V8 XJ Series/XK

303-S514

## Operation Of Throttle While In Closed Position – Service Action S514

Remove and destroy Bulletin 303-S514, dated 08/04.  
Replace with this Bulletin.  
Revisions are marked with a bar and in **bold text**.  
References to the tie strap for plastic adjustment nuts  
have been added on page 10.

ILLUSTRATION 16

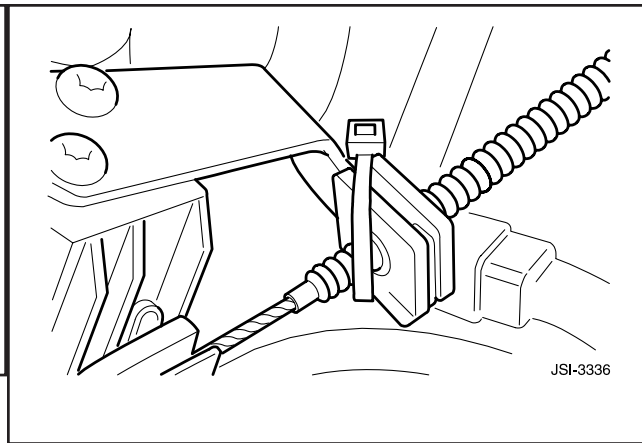
16. **⚠ WARNING: FOR VEHICLES WITH THE PLASTIC ADJUSTMENT NUT, AFTER CORRECT CABLE ADJUSTMENT, YOU MUST INSTALL A RATCHET TIE STRAP TO FULLY RETAIN THE ADJUSTER NUT IN ITS LOCATION WITHIN THE ABUTMENT BRACKET, (ILLUSTRATION 16) REFER TO RECALL ACTION R466.**
